Questions and Answers

(as of October 8, 2018)

BID #1011182

FIGURE
4.13-1

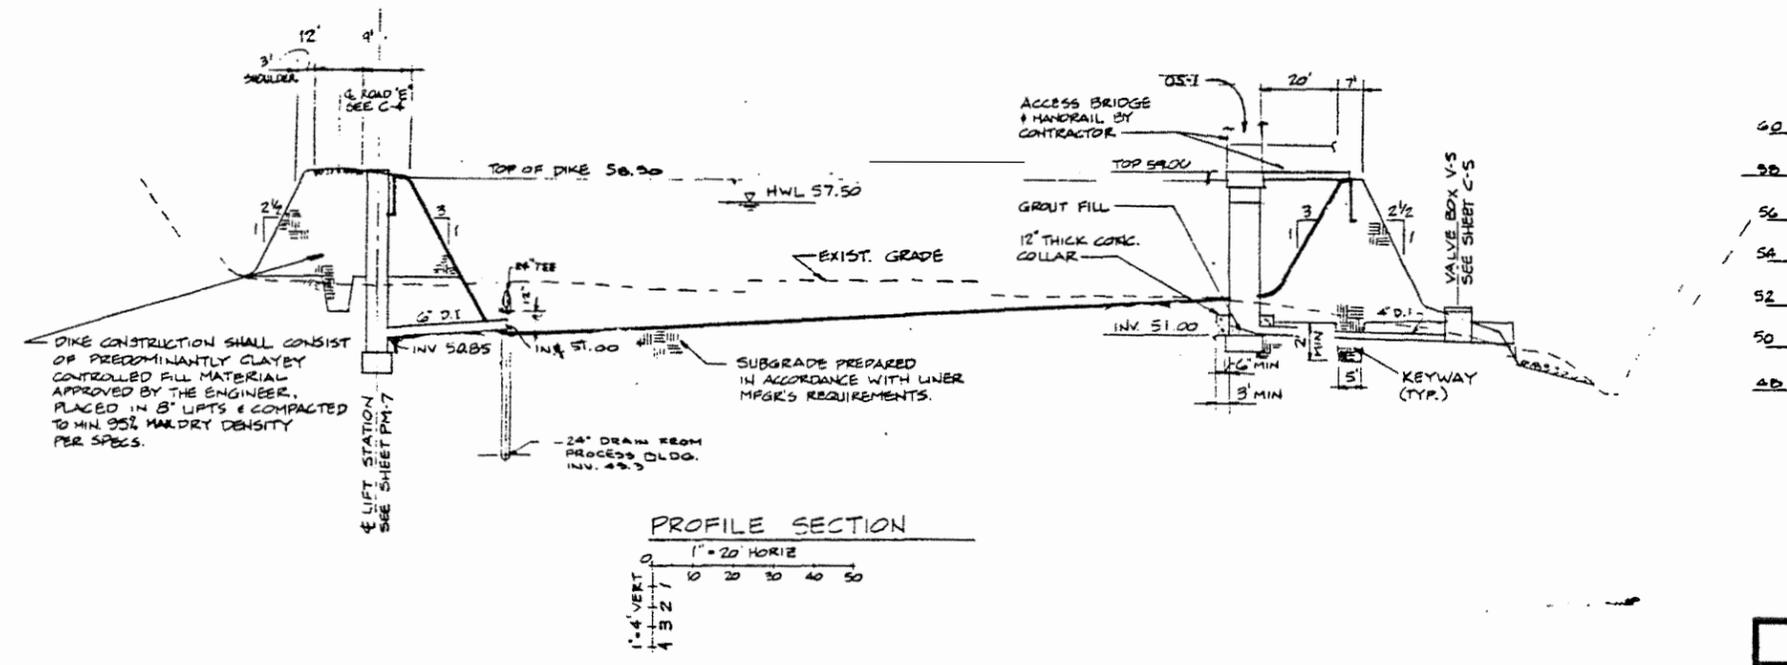
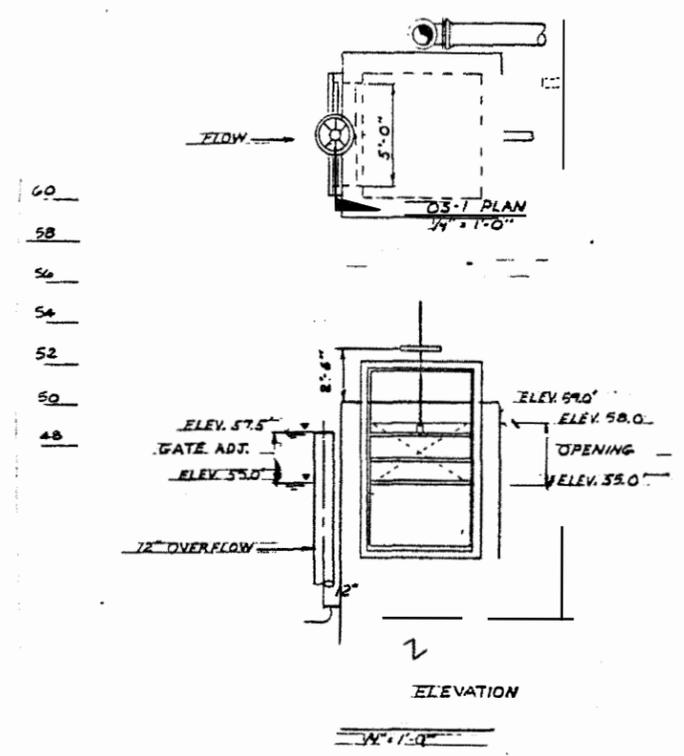
14. Are there as built drawings of the lagoon?

Response: Yes, see attachment A
